Tom Quinn
30 Christian Hill Rd, Amherst
Resident within 500' of Transformations Proposal
2/15/25

My name is Tom Quinn. I am the author of this white paper that compares the Transformations PRD proposal with other completed PRD projects in town. It is necessary to be clear that this white paper, and the comments/positions contained within, are my personal opinions as a citizen and neighbor of this project, not as a member of the Planning Board. I have recused myself from the Transformations case and will not participate in Board discussions or deliberations. As the comments made herein are my own, they in no way represent the views or opinions of other Planning Board members or the Board as a whole. No current Board members or alternates were consulted in the writing of this white paper. Lastly, any comments contained herein are specific to the Transformation proposal and are not intended to opine about any other current or future applications before the Board.

Driveway cuts on frontage road (16)

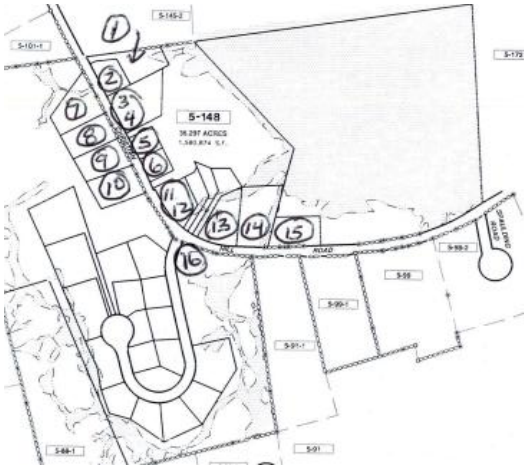
The Transformation proposal has extensive land clearing and construction along its frontage and its frontage is a scenic setback road. The units proposed along Christian Hill are reduced frontage lots, unlike existing homes, and many have their own direct frontage access. (16 new access points over 1500’ +/- of road). There will be large and unsightly storm water management features along the frontage or visible from it. The visibility of the farm, a selling point of the applicant, will be limited due its smaller size and housing units being constructed between it and the frontage. Homes are being proposed virtually everywhere that is buildable (all of this area directly abuts frontage) and there are some encroachments on wetland areas.
